***MODIFICATION REQUEST:***

***Clemton Park Village,  
60 Charlotte Street, Campsie  
Former Sunbeam Factory  
Concept Plan MP 07\_0106 MOD 6***

Secretary's Environmental Assessment Report  
Section 75W of the  
*Environmental Planning and Assessment Act 1979*

September 2014

**Figure 4:** Lot 42 Likely building envelopes as proposed (Source: Proponent's application)

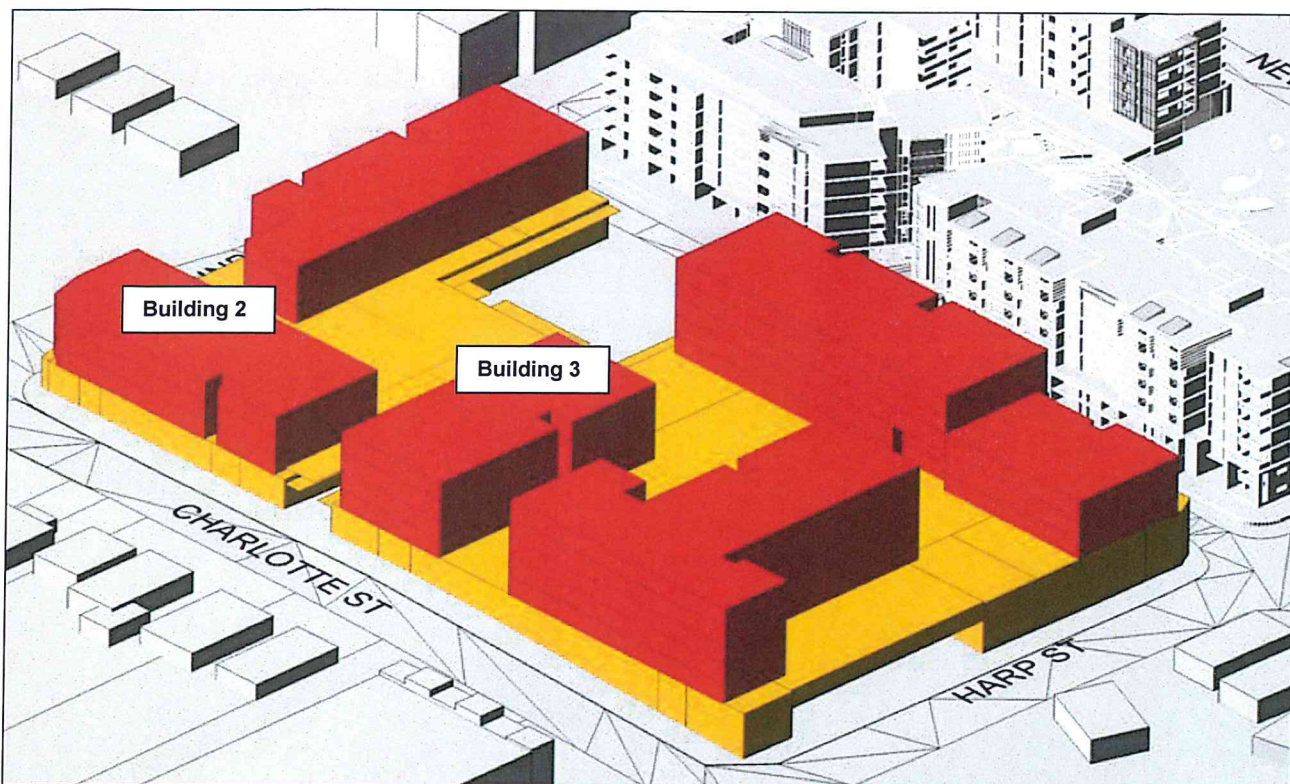
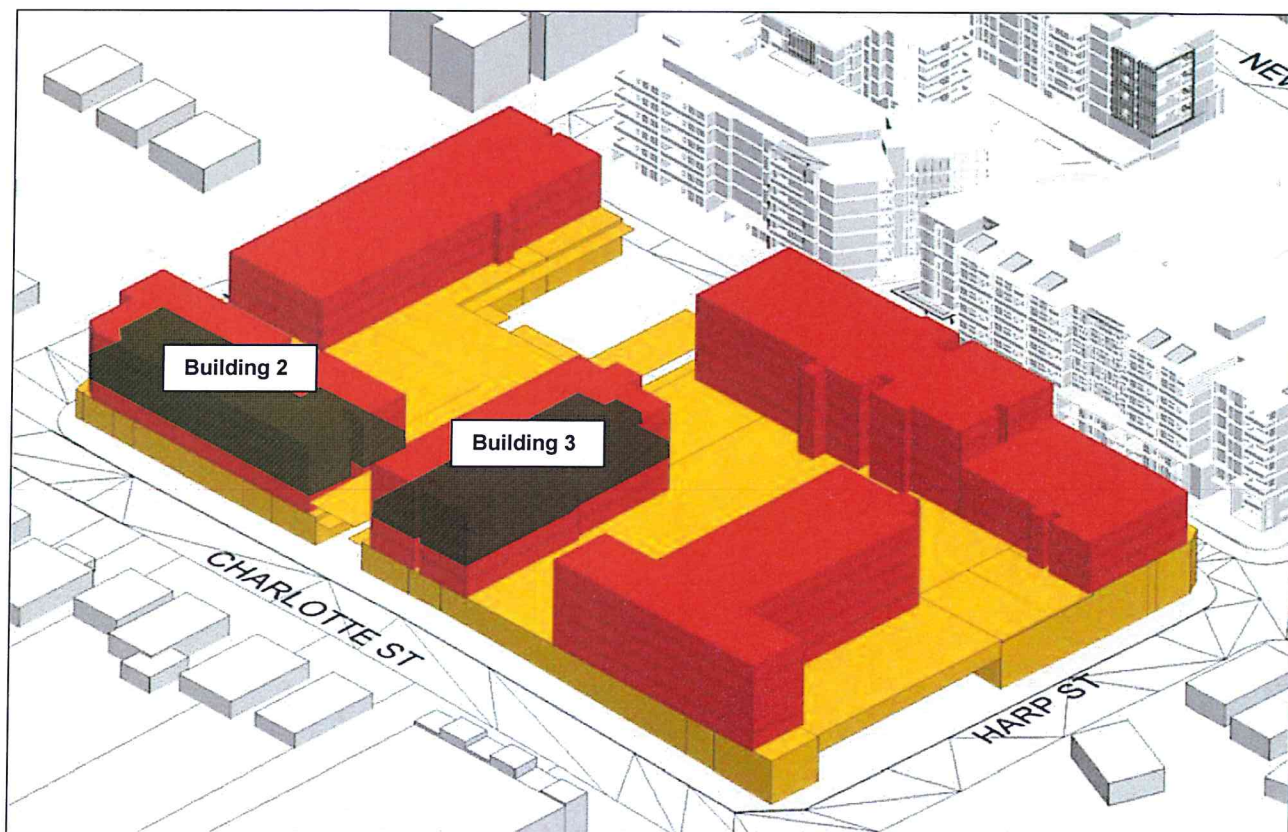
- increasing the height of Building 2 by 1 storey (from 3 to 4 storeys above the podium); and
- increasing the height of Building 3 by 1 storey (from 4 to 5 storeys above the podium).

A comparison of the approved and proposed building envelopes is shown in **figures 3 and 4**.

In terms of visual impacts, the Department's assessment concludes that the proposed increase in height is acceptable. The increased height of Buildings 2 and 3 falls within the range of heights (3 to 8 storeys or 10.2 to 25 metres) already approved on the Concept Plan site and on Lot 42 (all of which already exceed the 10m LEP height control). As such the proposed modification does not increase the overall maximum height or any substantive visual impacts.

Furthermore, Lot 42 was designed to incorporate substantial breaks in building massing above the podium level along Charlotte Street. These visual breaks are maintained under the modification and assist with offsetting the additional visual bulk of the proposed additional storey on Buildings 2 and 3.

Despite the additional storey, Building 2, would remain smaller than Buildings 3, 4 and 5 on Lot 42 and therefore is not considered to present as overly dominant within the locality, or result in any material adverse visual impacts.

The impact of the additional massing from Building 3 is considered relatively minor as it presents only a short edge to Charlotte Street. Further, Building 3 achieves the same maximum RL height as Building 4 adjoining to the south. Therefore, Building 3 is not considered to present as overly dominant within the streetscape, despite the proposed increase in height.

Further, the proposed additional storey on Buildings 2 and 3 is considered acceptable and will not result in any adverse visual or amenity impacts.
